CARDS 0 & 1, MODULE CTAXF133 @12W
INSTALLED 3-14-23 REMOVED 3-21-23
BEFORE TERMINATION MODIFICATION

TERMINATION MODIFICATION

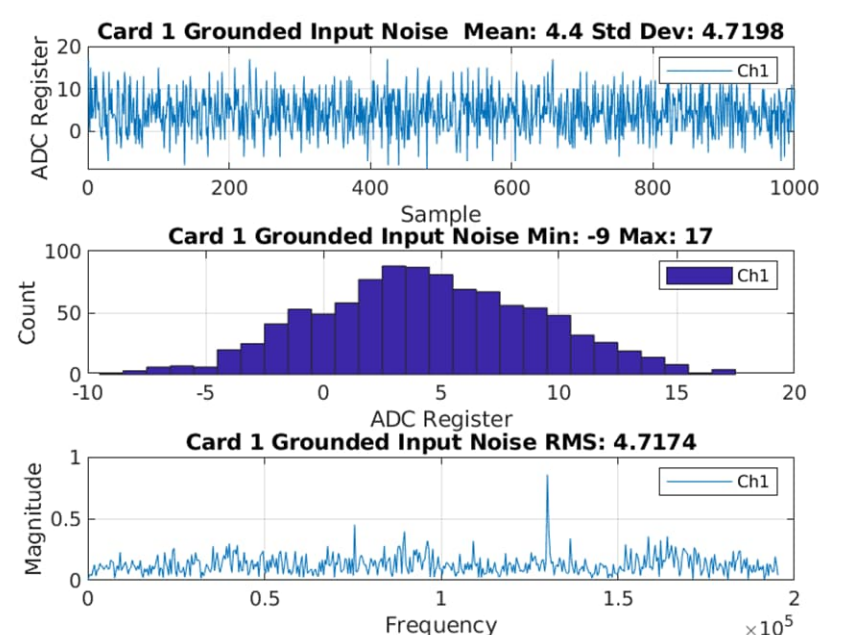
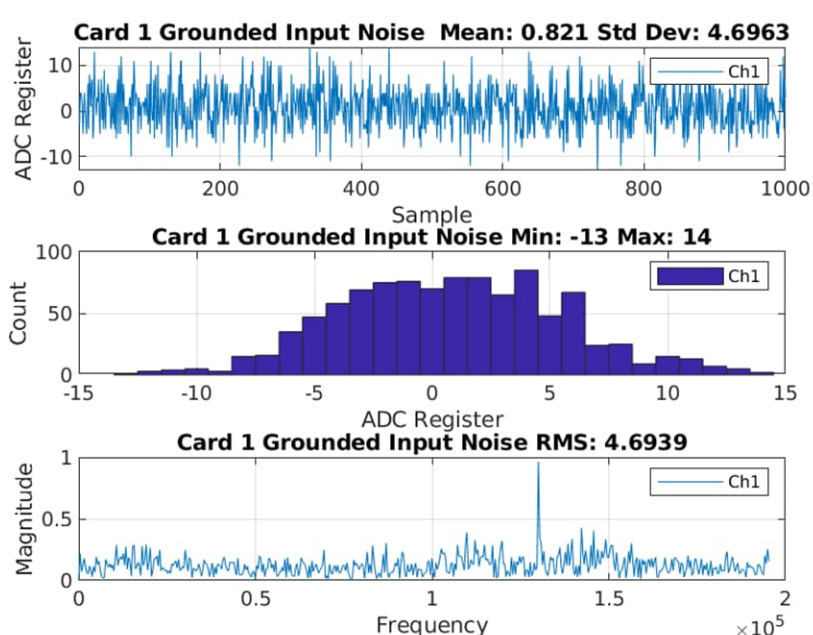
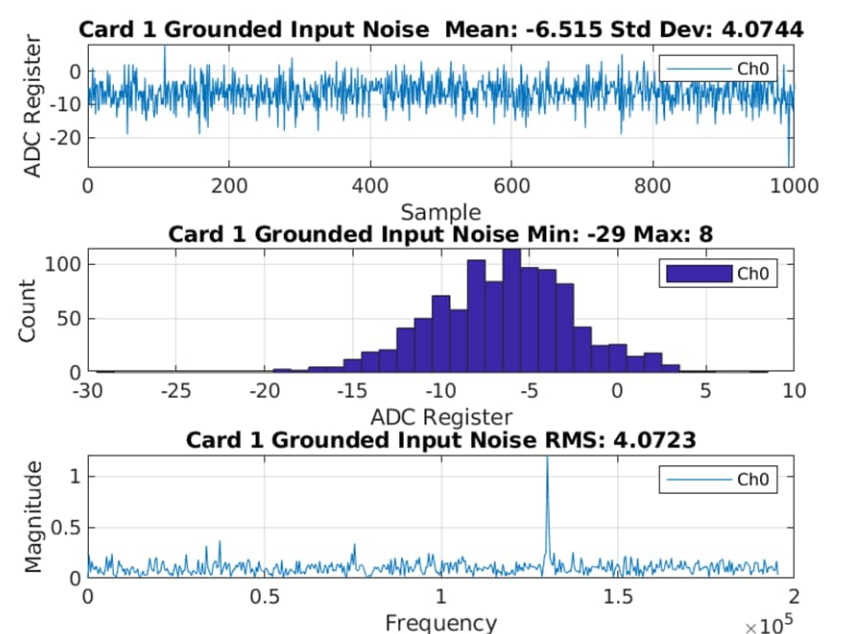
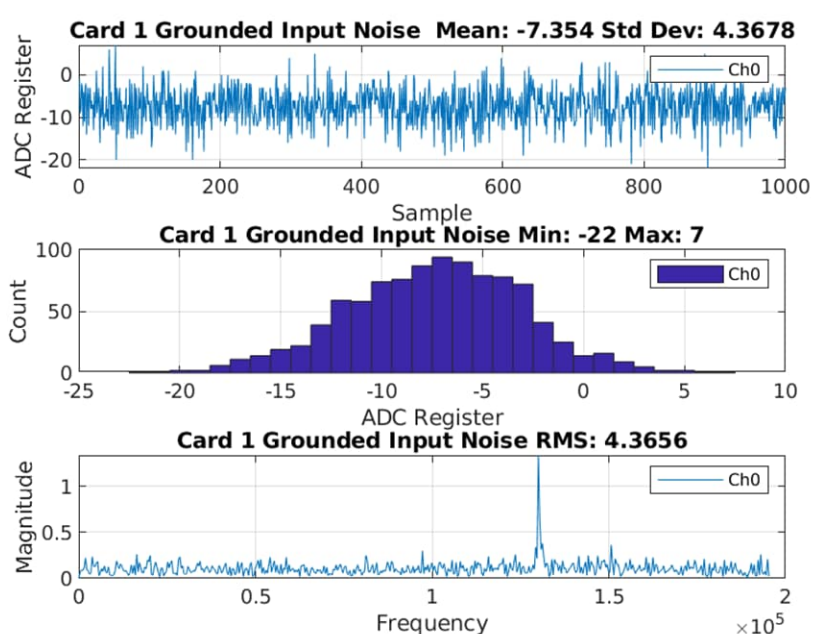
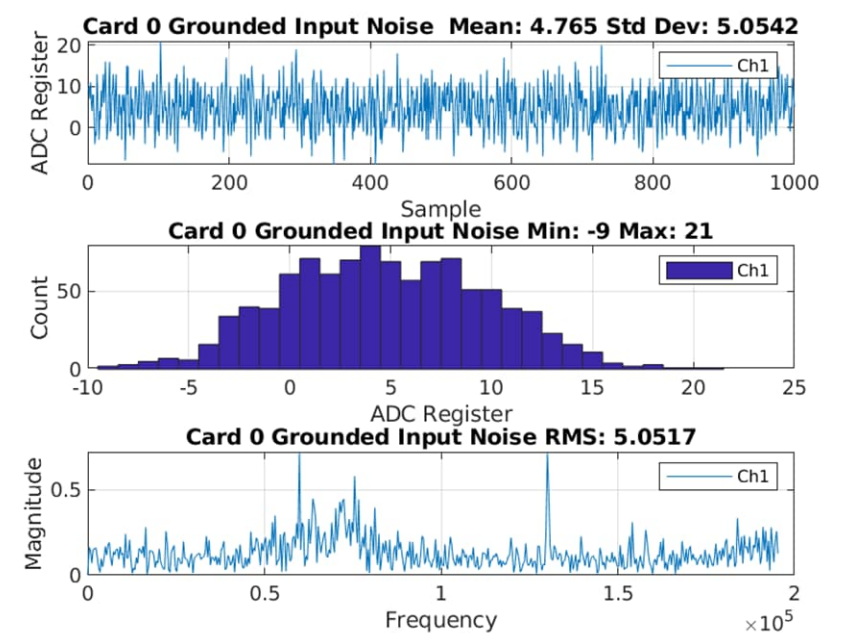
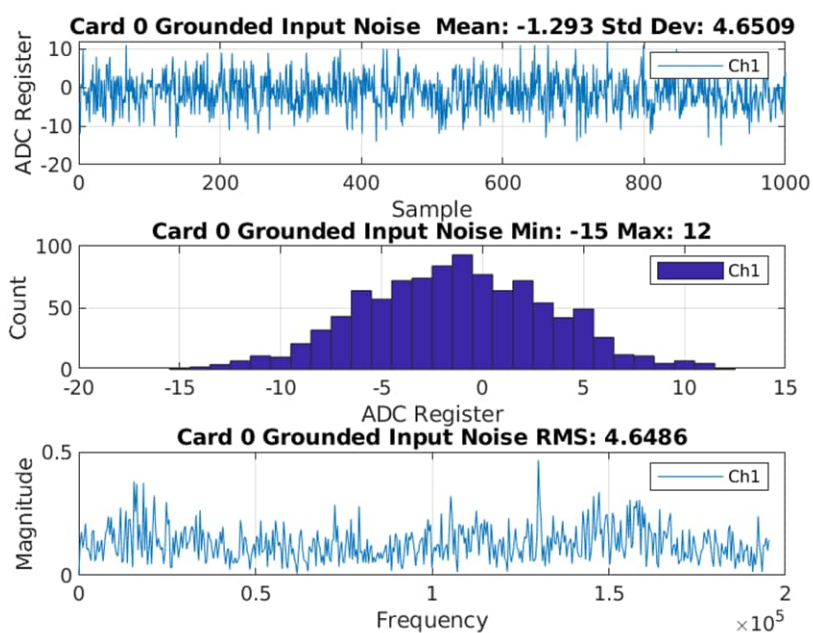
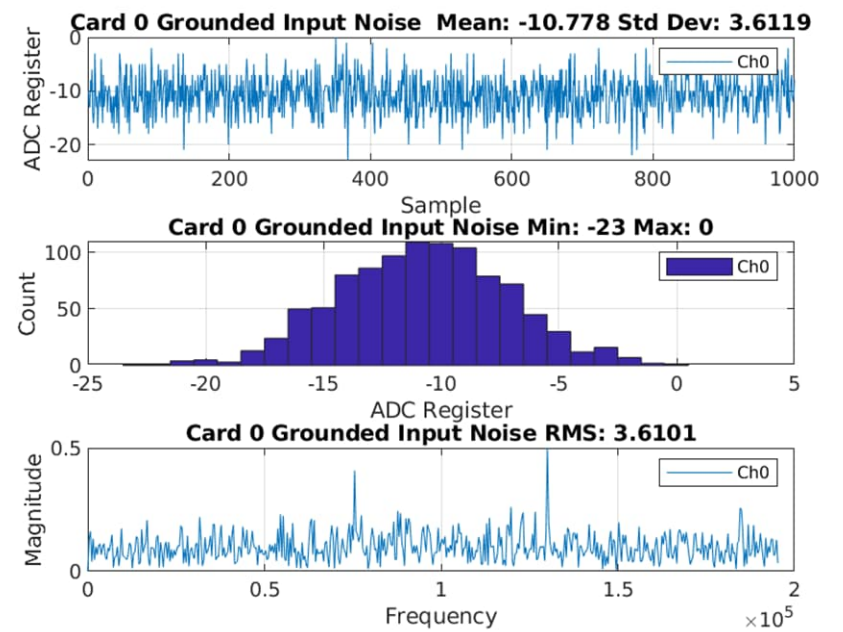
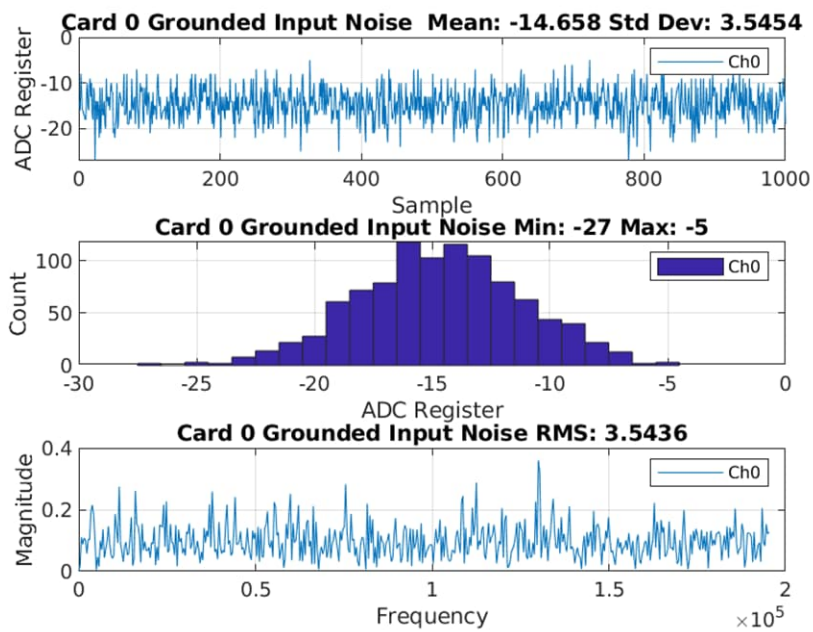
CARDS 0 & 1, MODULE CTAXF133 @12W
AFTER TERMINATION MODIFICATION
ON 3-21-23

1. Remove: R67 49.9 ohm (extra termination)
 Replace: DNP
2. Remove: R63, R66, R68 16.9 ohm (6dB attenuator)
 Replace: 0 ohm jumper
3. Remove: R58, R84 49.9 ohm (excess termination)
 Replace: 100 ohm
4. Remove: R72, R96 49.9 ohm (extra termination)
 Replace: DNP
5. Remove R71, R75, R94, R98 33 ohm (excess termination)
 Replace: 100 ohm

CARDS 0 & 1, MODULE CTAXF133 @12W
INSTALLED 3-14-23 REMOVED 3-21-23
BEFORE TERMINATION MODIFICATION

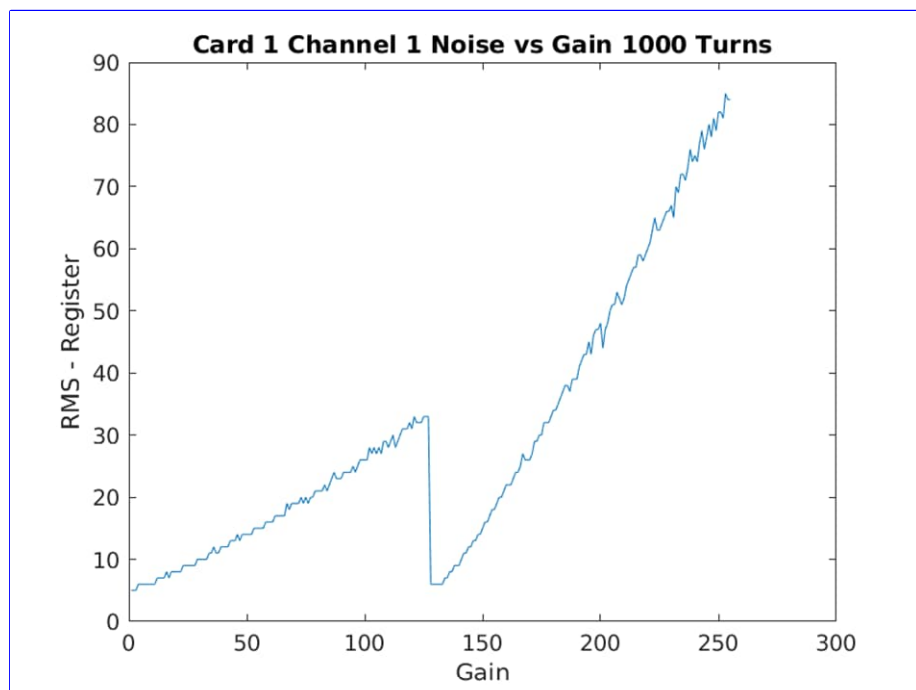
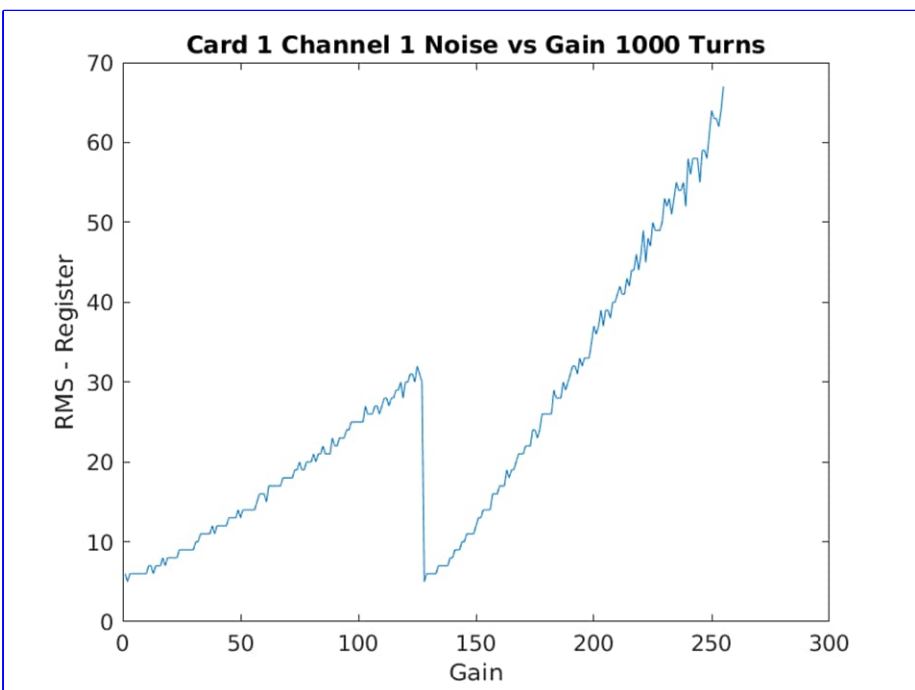
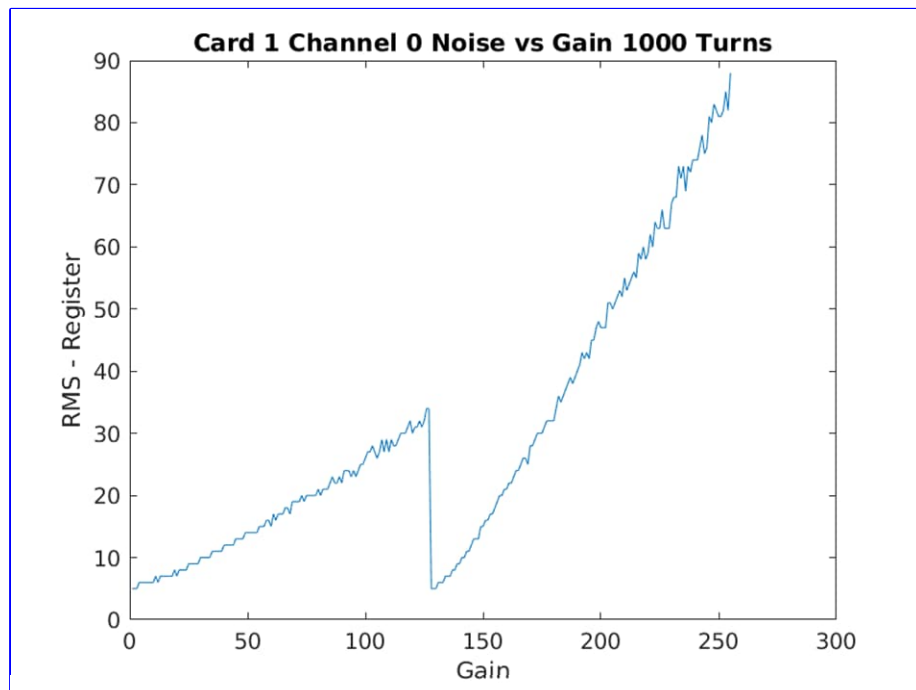
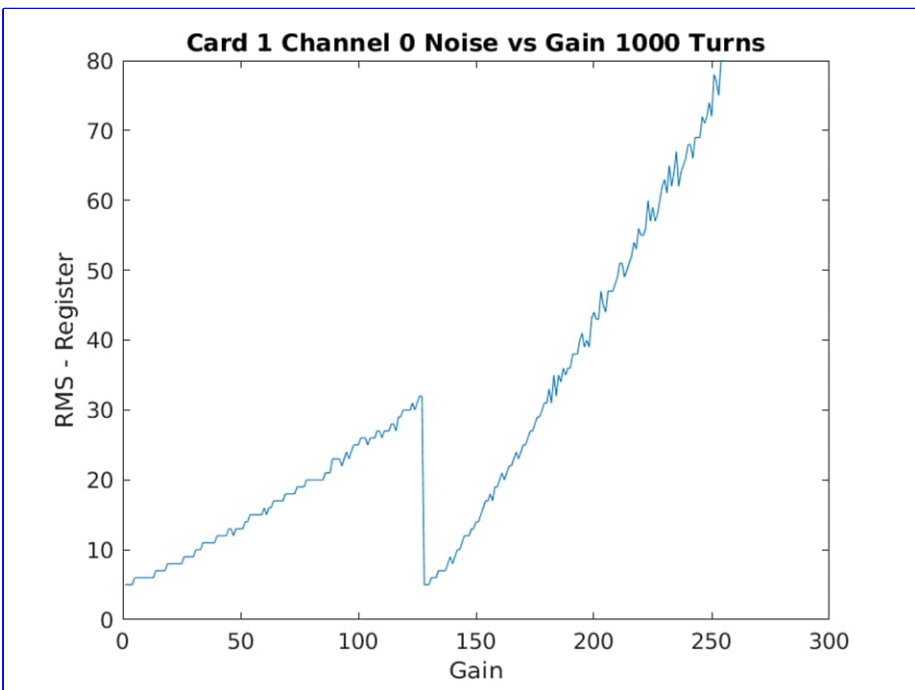
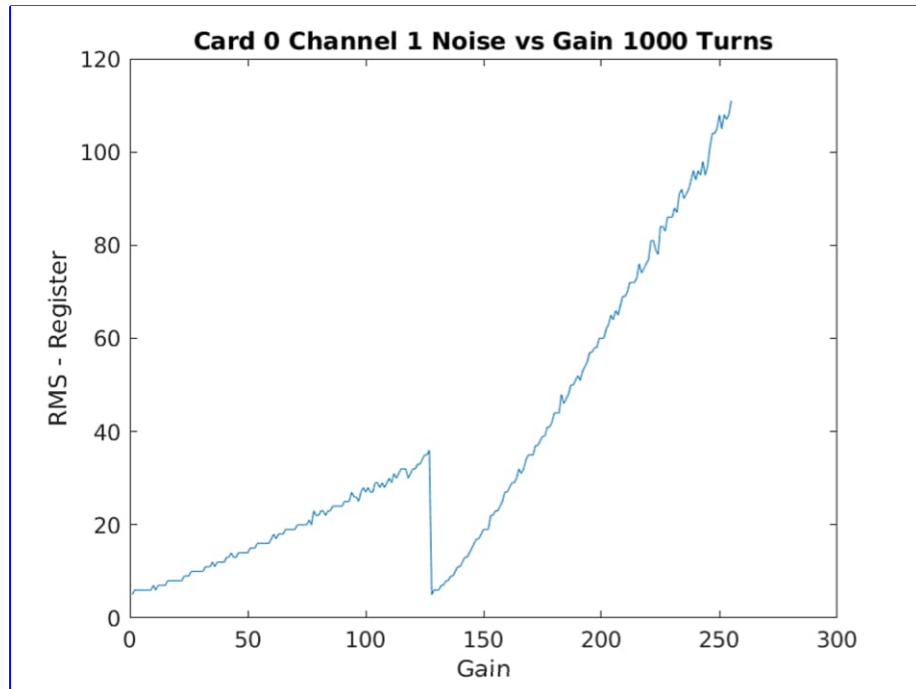
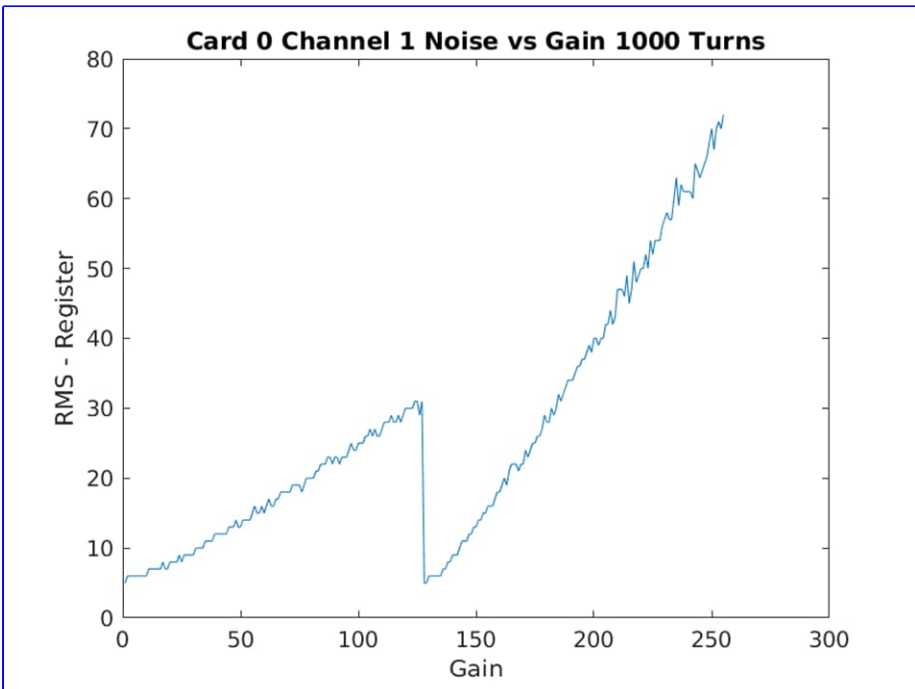
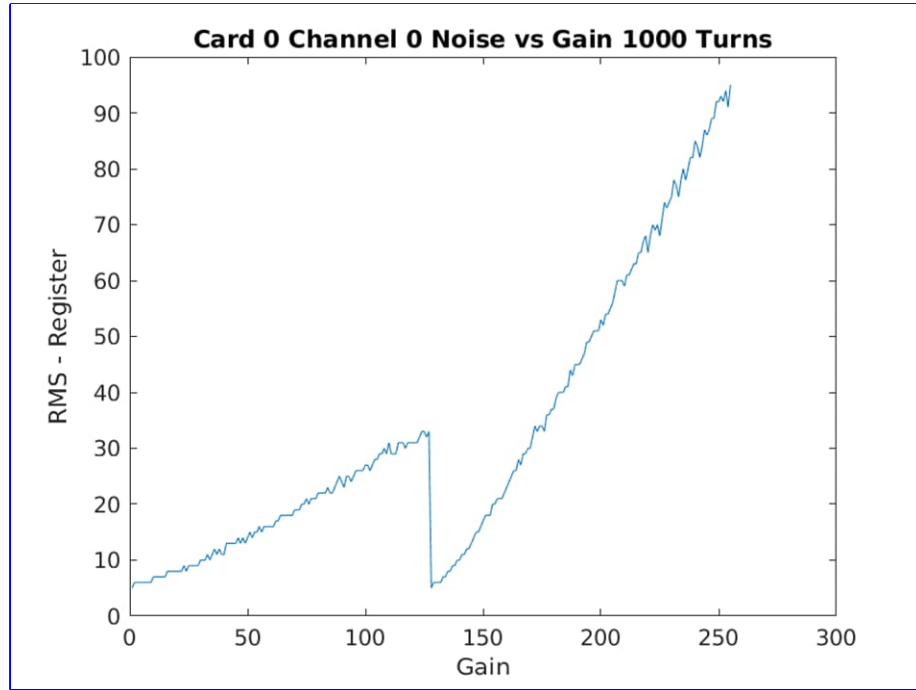
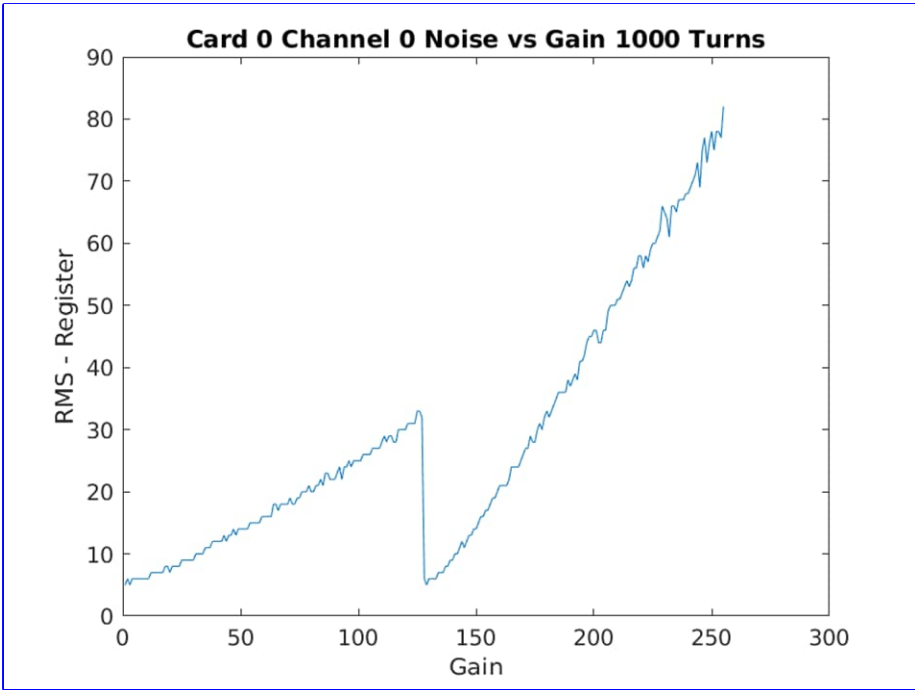
CARDS 0 & 1, MODULE CTAXF133 @12W
AFTER TERMINATION MODIFICATION
ON 3-21-23
